**Planned Unit Development & Replat – Lot 19
Southport West and Lots 1, 2, and 3 Southport
West Replat Seven – Southport Parkway, LLC**

**CITY OF LA VISTA
PLANNING DIVISION
RECOMMENDATION REPORT**

CASE NUMBERS: PPUD21-0001;

Staff Review Letters

Figure 1. Proposed site plan for Southport North Lots

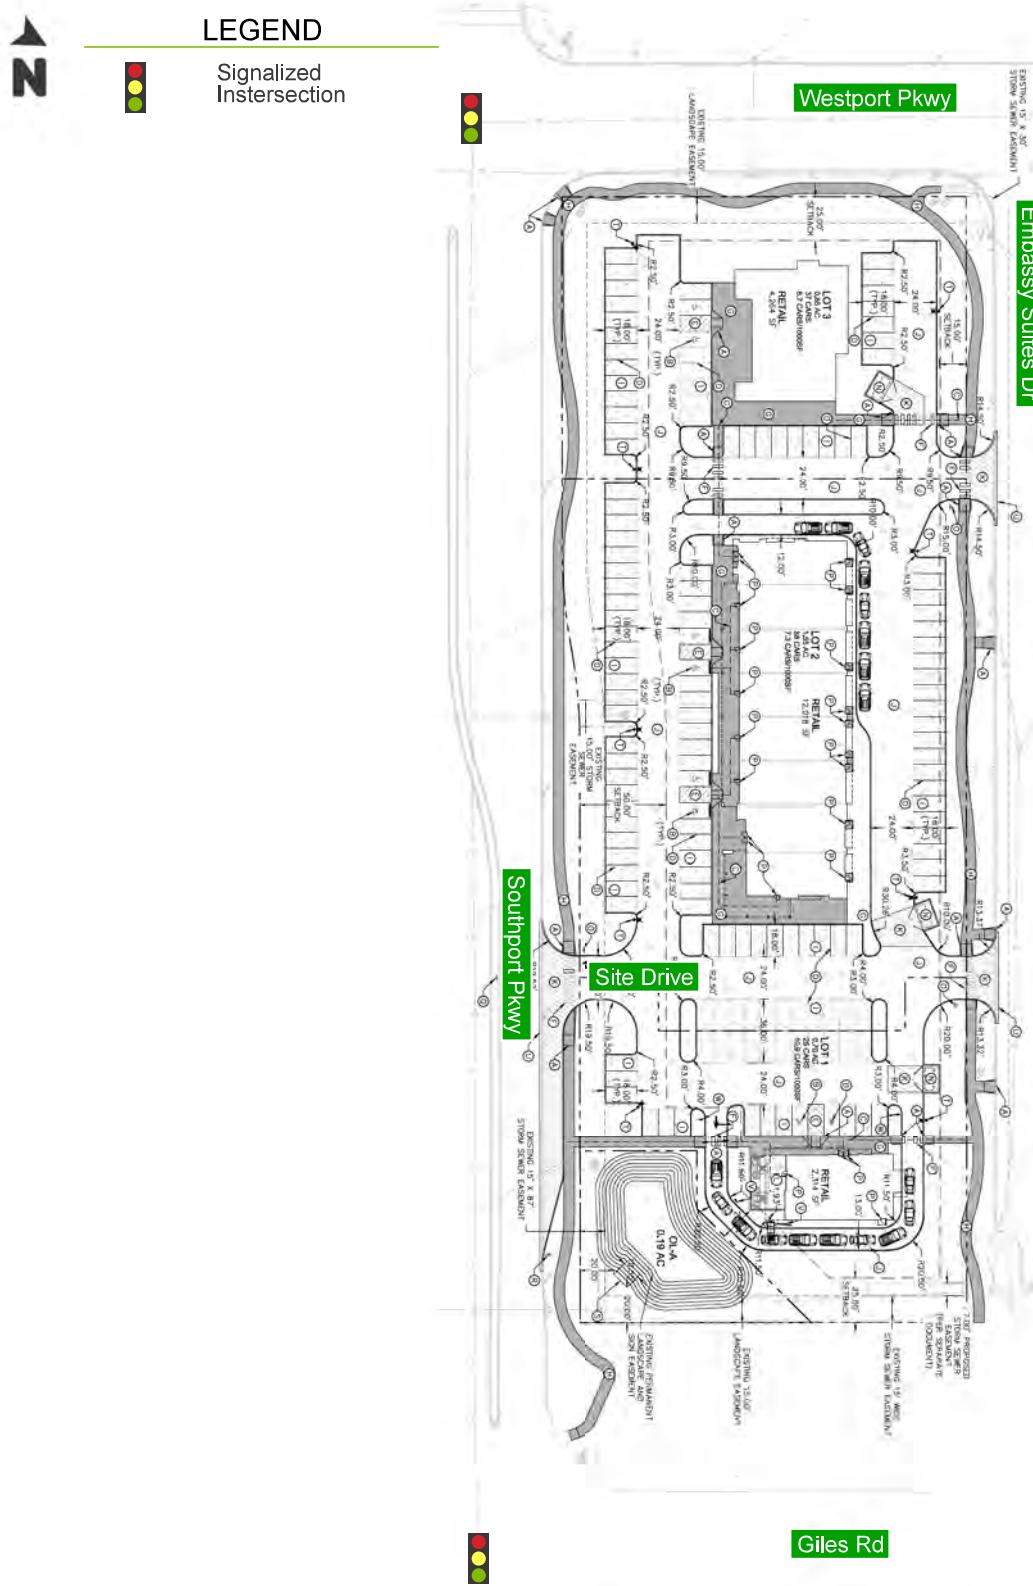
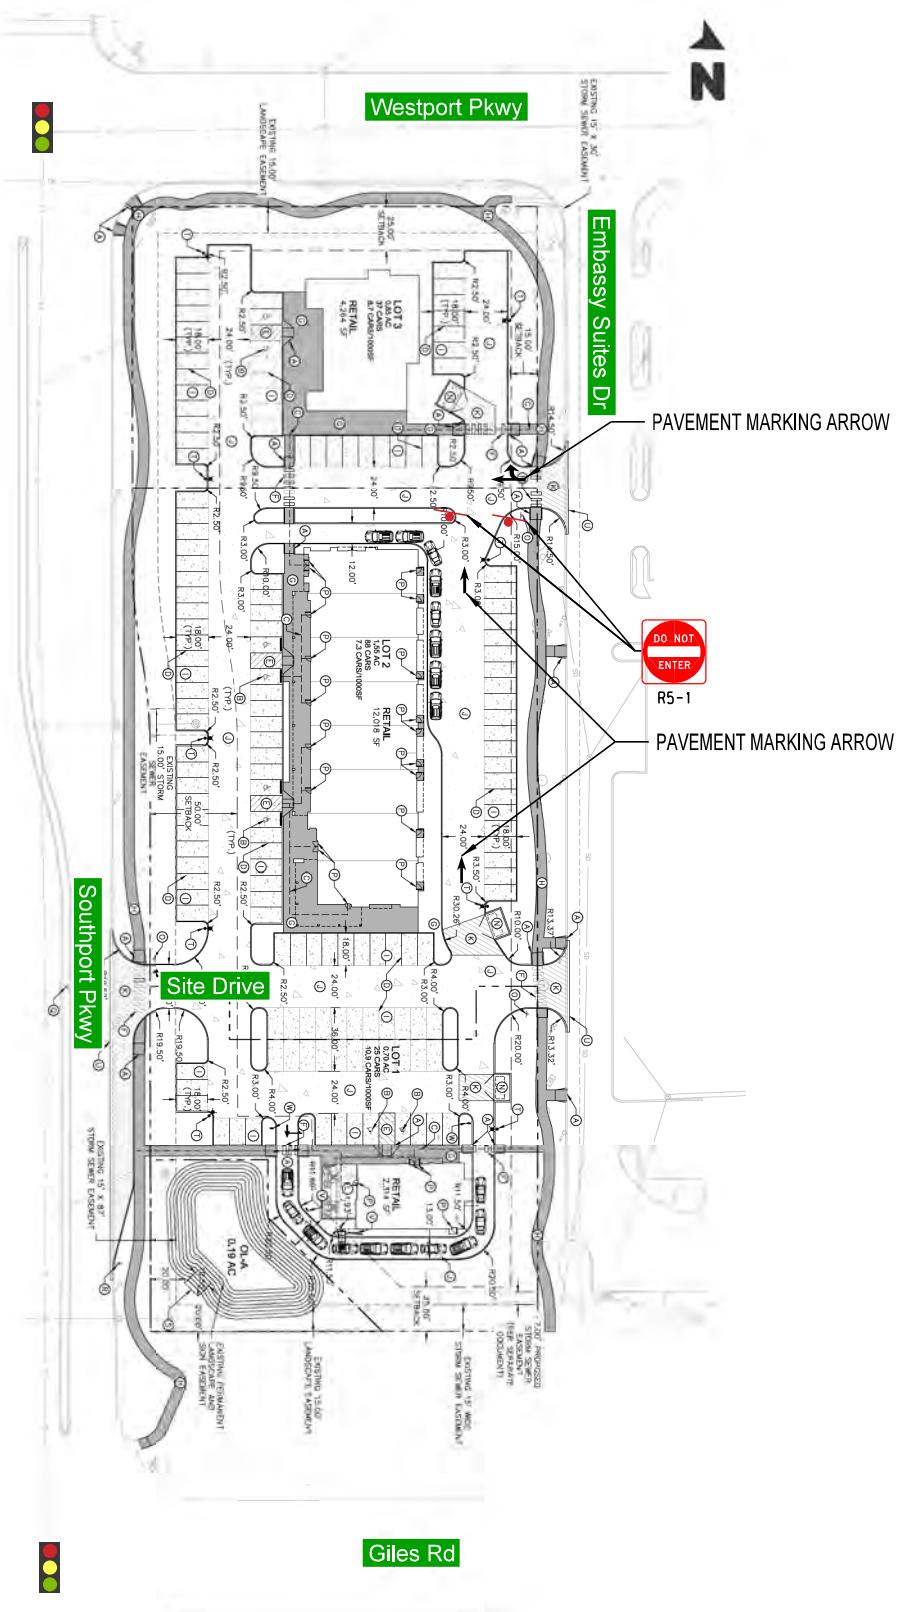
1. In general, we concur with the analysis scenarios as developed by Olsson for this study for the 2019 Existing, 2022 Background, and 2022 Opening Day/Plus Site analysis years. The Brixmor North Traffic Impact Study was used to develop the traffic volumes for this project.
2. Page 6 / Figure 1 & Page 14 / Figure 9: The north arrow on these figures is inaccurate.

Please have the applicant show the correct north heading or reorientate the site plan so north is up on the page.

Figure 3. Pass-by trip distribution

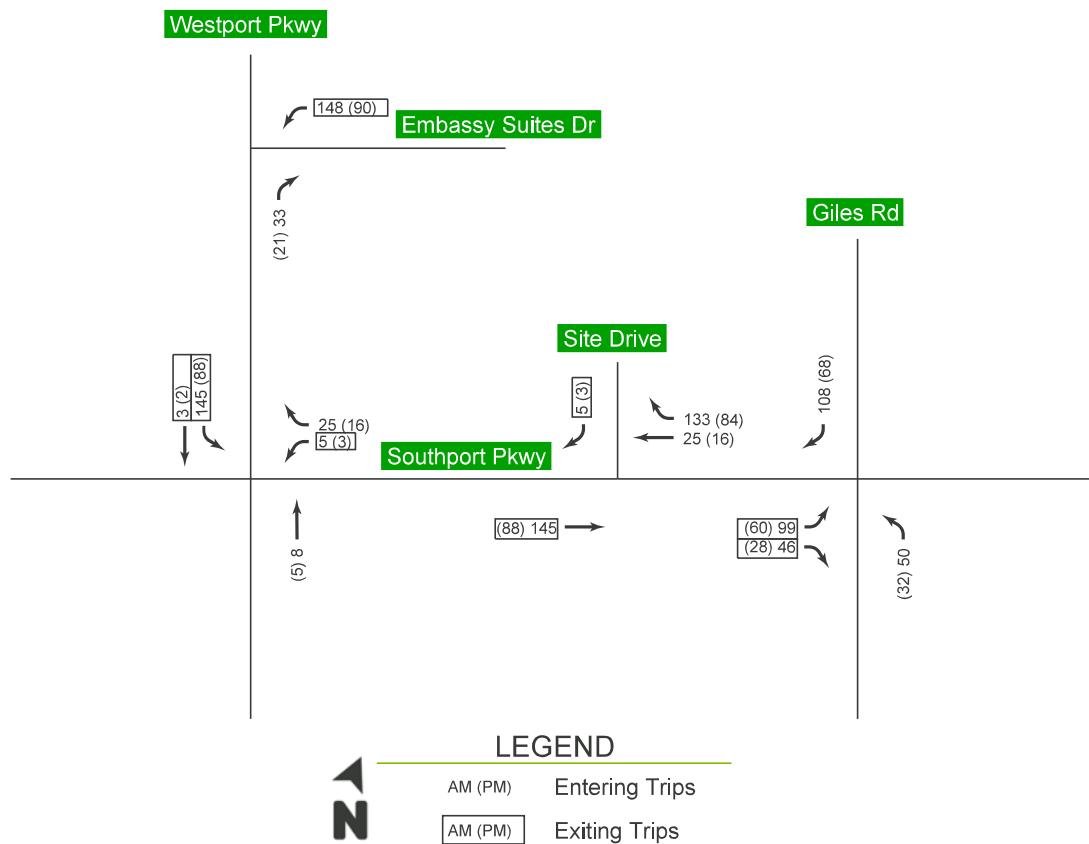
5. Page 4 / Paragraph 3 &Page 8 / Figure 3: At the Site Drive (RIRO access), with only 17 vehicle-trips in the AM and 18 vehicle-trips in the PM, is the right-out justified at this location and a right-in only needed? See example east of Giles Road on Southport Parkway. With the right-in only option, the access point could be shifted further west away from the Giles Road

intersection. A shift west would deter cut through traffic to the Embassy Suites and provide additional on-site staking for the proposed coffee shop. Additionally, limiting the access to right-in only will eliminate the concern of exiting traffic crossing multiple lanes of traffic on Southport Parkway to access the dual westbound left-turn lanes.
